Re: Ashland Lakefront Site -- Sediment Remedy

B. NSPW’s Evaluation of the Weston Report

When the ROD was issued, NSPW was made aware of a report for the first time prepared by EPA’s consultant, Weston Solutions, Inc. (“Weston”), titled “Conceptual Geotechnical Assessment For Sediment Removal at the Ashland/Northern States Power Lakefront Site in Ashland, Wisconsin” (“Weston Report”). Although the report is dated November 20, 2009 (after the close of the public comment period for the Proposed Plan on August 17, 2009), it was not provided to NSPW until more than **a year later** in October 2010, *after the ROD was issued*. It appears that the remedy selection in the ROD was based, at least in some material part, on the analysis in the Weston Report. The Company has now had an opportunity to review the Weston Report and has asked three separate consultants (Anchor QEA LLC, Gradient and Burns & McDonnell) to independently review it. Each of these firms comprise nationally-regarded

Fig. 1. Depiction of Basal Heave Failure

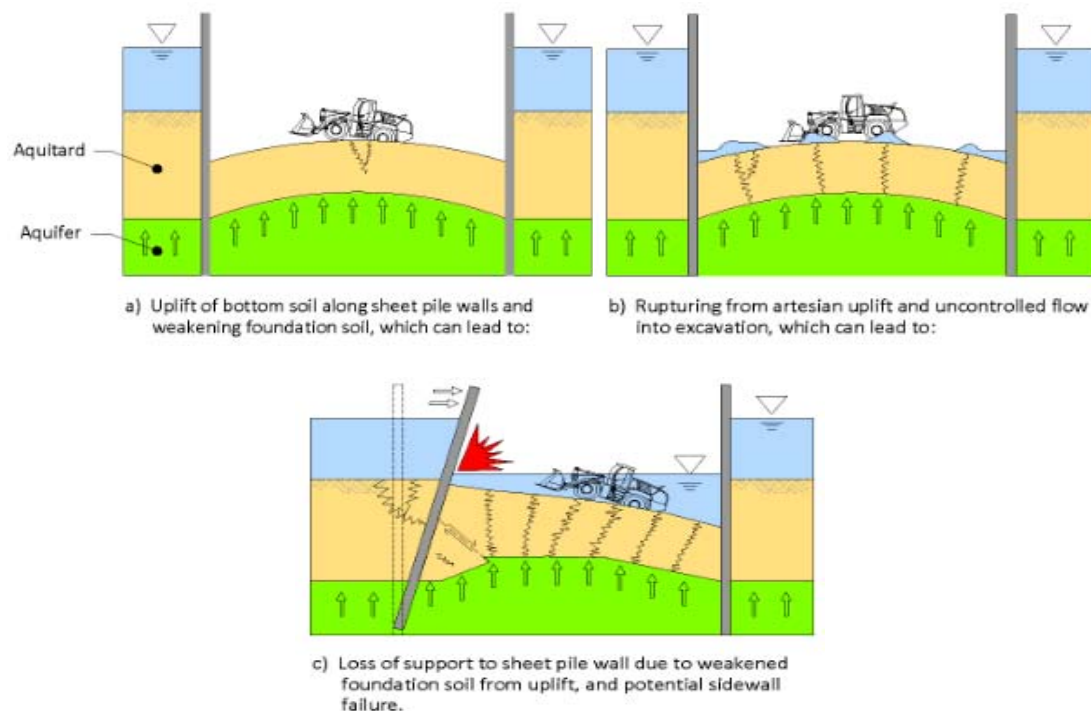
- **The Dry Dredge Increases The Risk Of Basal Heave And Bottom Instability:** Removing bay water and sediments overlying the Copper Falls aquifer poses significant potential for bottom upheaval and basal heave failure. Anchor Report, at 4-5. If such failure were to occur, the artesian conditions in the underlying aquifer could blow water upward through the excavation bottom and lead to a complete collapse of the containment wall, resulting in potentially catastrophic risks to worker safety and construction disruption. In addition to presenting unsafe conditions for workers, a basal heave failure could also lead to dislodgment or mobilization of previously contained sediments and NAPL (which is currently contained by artesian conditions), leading to irreparable damage to the aquitard and exacerbation of Site conditions. Anchor Report, at 5. In such a case, there would be no corrective action available – the damage to the aquitard is irreversible.

Fig. 2. Depiction Of Sheet Pile Wall Collapse

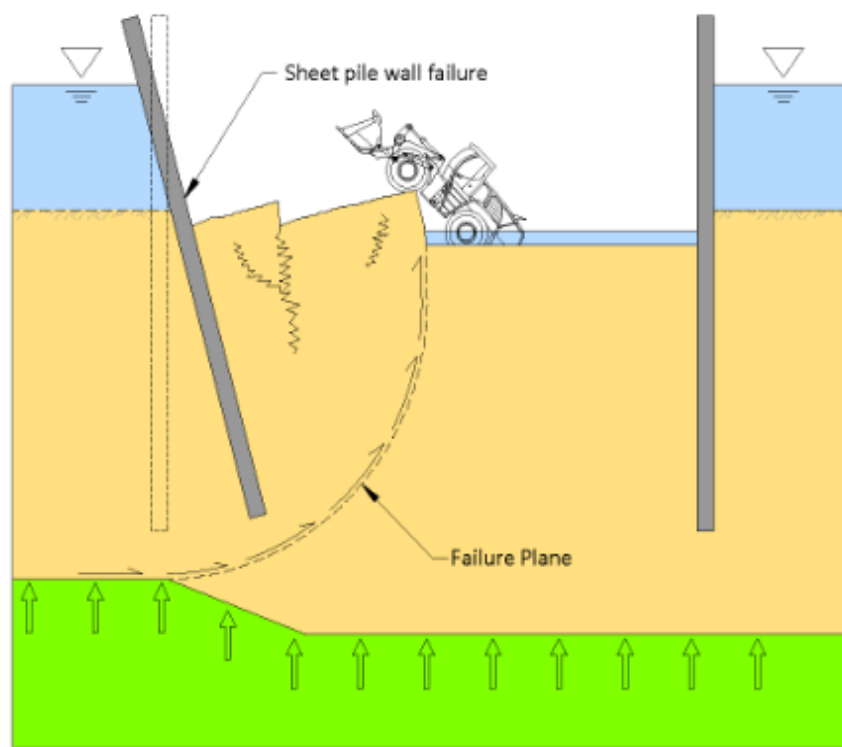
- The Dry Dredge Risks Sheet Pile Wall Collapse:** High energy wave conditions, or deep cuts to the aquitard required to install containment could result in failure of the containment wall, the consequences of which would be catastrophic to workers and equipment within the dry excavation area. Anchor Report, at 44-45. Integrity of the containment structure may also be a concern in the event that unforeseen subsurface conditions or other scheduling delays require dry excavation to be conducted over multiple seasons, as the ROD design does not appear to account for effects of ice damage to the containment wall. To assure a safe design, a more robust (and expensive) cofferdam structure is likely required; however, even a cofferdam (which was not analyzed in the Feasibility Study or ROD), may not meet the necessary safety factor to ensure stability. *Id.*, at 45.

Fig. 3. Depiction of Piping Caused By Sheet Pile Installation

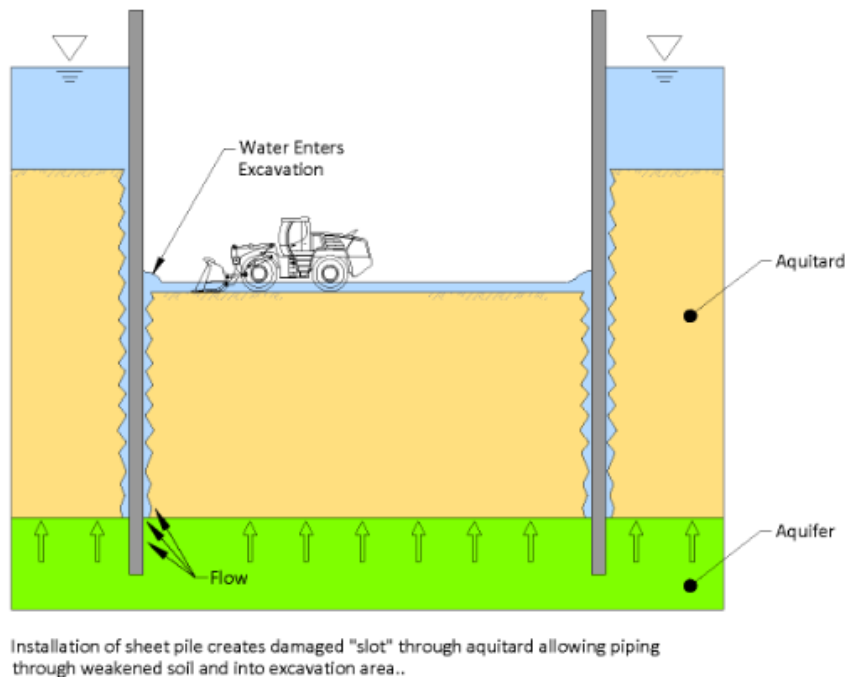
- The Dry Dredge May Not Be Implementable Due To Various Site-Specific Failure Mechanisms:** The ROD also fails to acknowledge numerous other Site-specific circumstances that affect the implementability of the dry dredge, including (1) piping caused by installation of the sheet pile wall; (2) the impact of wind, waves, and ice on the sheet pile wall; (3) the need for exploratory trenching to locate and remove obstructions; (4) the effect that the stiff composition of the aquitard may have upon efforts to install the sheet pile wall; (5) the potential for difficult sheet pile

driving conditions to result in compromised interlocks; (6) the potential that scour caused by the wall will mobilize existing sediment contaminants; and (7) technical difficulties associated with dewatering the “dry” remedial area. Burns Report, at §§ 4-5.

Table 1
Summary of Soil Profile Developed by Weston

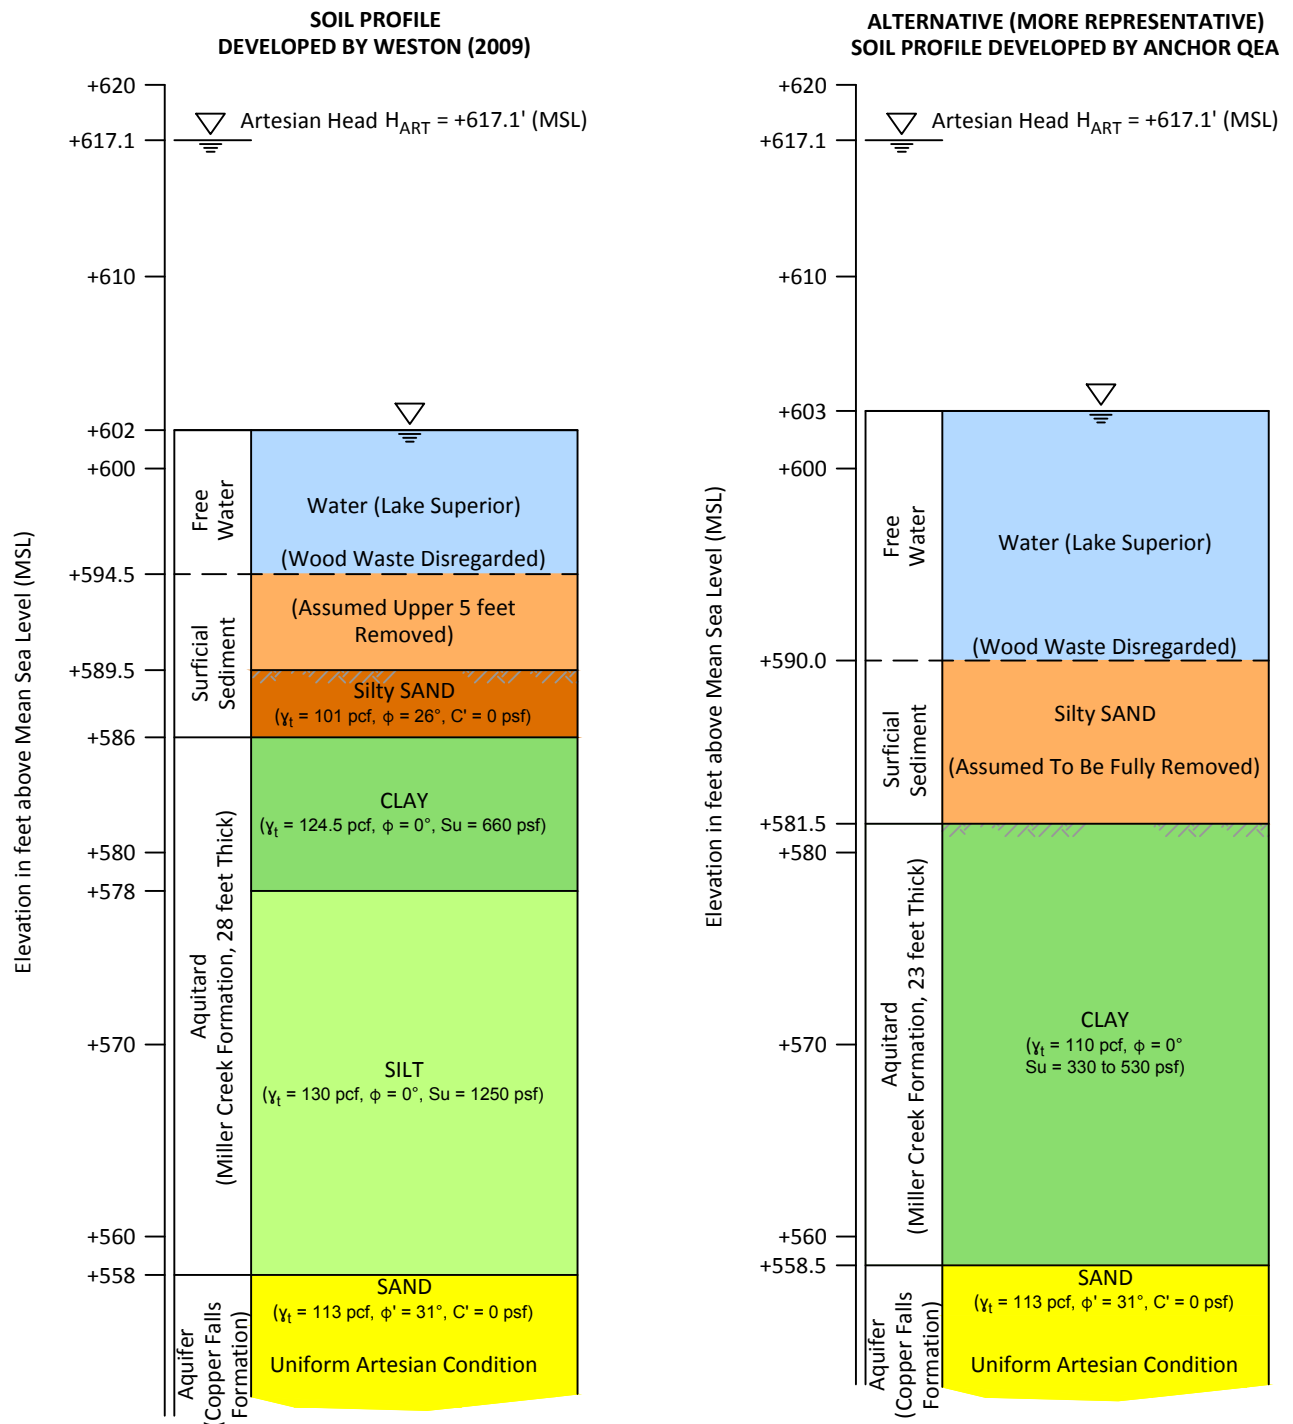
Weston used the above-mentioned information to develop a singular soil profile, which served as the basis for its analyses. The resulting soil profile is presented on Figure 2, while Table 1 presents a summary of Weston's approach for developing assumptions for each component of the soil profile.

Figure 1 Illustration of Potential Impacts from Basal Heave Failure at the Ashland Site

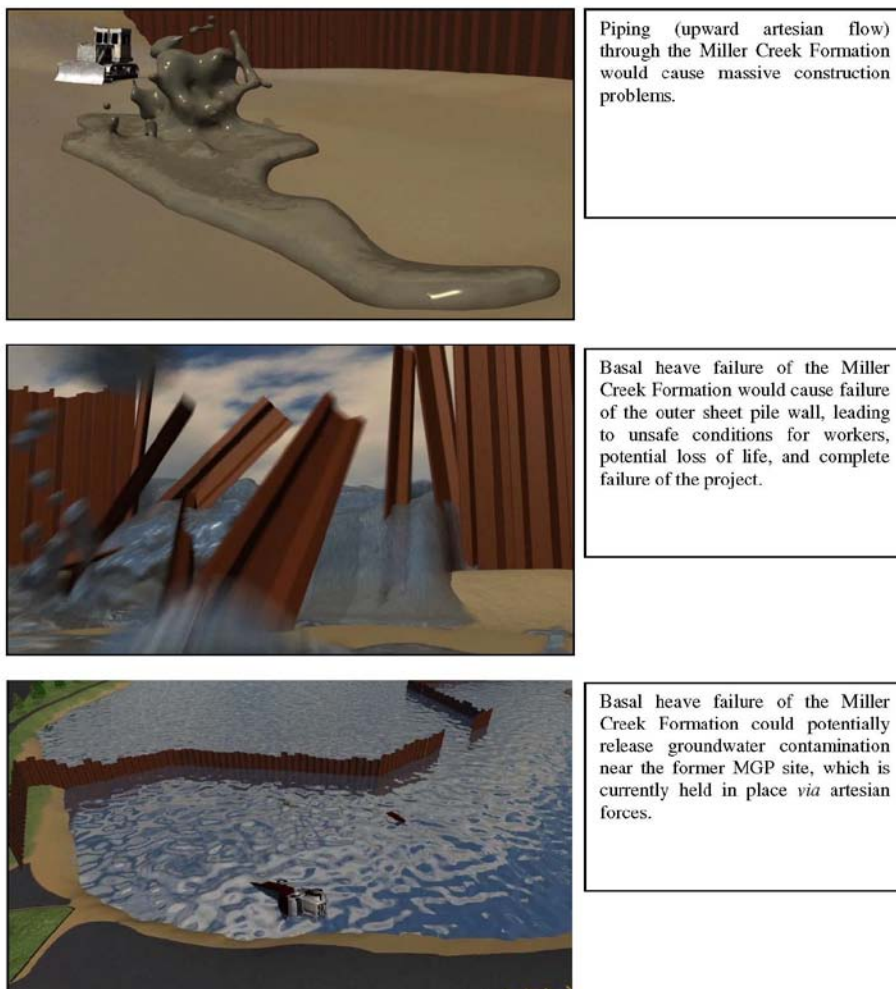
The bottom-line conclusion from the analyses performed by Weston in response to the "basal heave" analysis performed for NSPW is that implementing the SED-6 alternative has the potential for catastrophic "fatal flaw" failure with "significant worker/equipment safety concerns" (Weston, 2009). These safety risks likely exceed the relatively minor chemical exposure risks currently posed to human health and the environment at the Ashland Site. This "basal heave" analysis, presented in the PRAP comments (pp. 24-26), demonstrated that there are safety concerns uniquely associated with the "dry dredge" component of the SED-6 remedy alternative. Implementing SED-6 may lead to geotechnical failure posing significant risk to remediation workers and the environment. Basal heave failure would likely mobilize and release contaminated sediment to uncontaminated portions of Chequamegon Bay and breach the Miller Creek confining layer, thereby mobilizing the deep groundwater (Copper Falls Aquifer) contaminant plume. Thus, if geotechnical failure occurred, greater volumes of sediment and groundwater would be impacted. See Figure 1, below.

Figure-3-1: Conceptual Site Model and Evaluation of Basal Heave Potential, as depicted in the Technical Work Group Meeting in Madison, WI on May 29, 2009

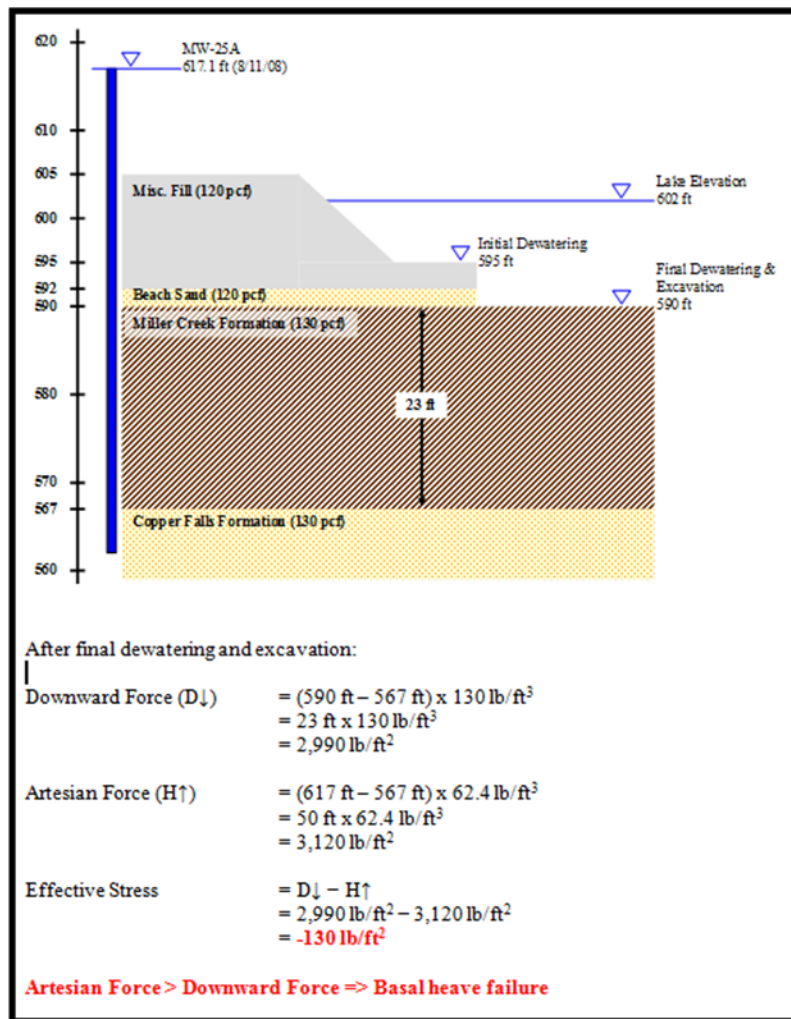
- The “base” condition established by Foth and Van Dyke and presented in Figure 3-1 above provides a net uplift pressure (heave condition) of 130 pounds per square foot (psf). This net uplift condition can also be expressed in terms of a factor of safety, determined by dividing the downward pressure by the artesian pressure. In systems where all variables, material properties, and forces are known, a factor of safety value equal to or greater than one theoretically indicates a stable condition, while a factor of safety value less than one indicates imminent failure will occur before the design load is met (in the case of Ashland - a net uplift, or basal heave condition). Because of soil and other variability in natural settings, industry standards vary for acceptable minimum factor of safety values. These standards generally vary from 1.25 – 2.0 (also see Section 2.3). For the conditions depicted in the “base” Foth and Van Dyke case, a factor of safety against basal heave of 0.96 is calculated – an unsafe condition where basal heave may be imminent.
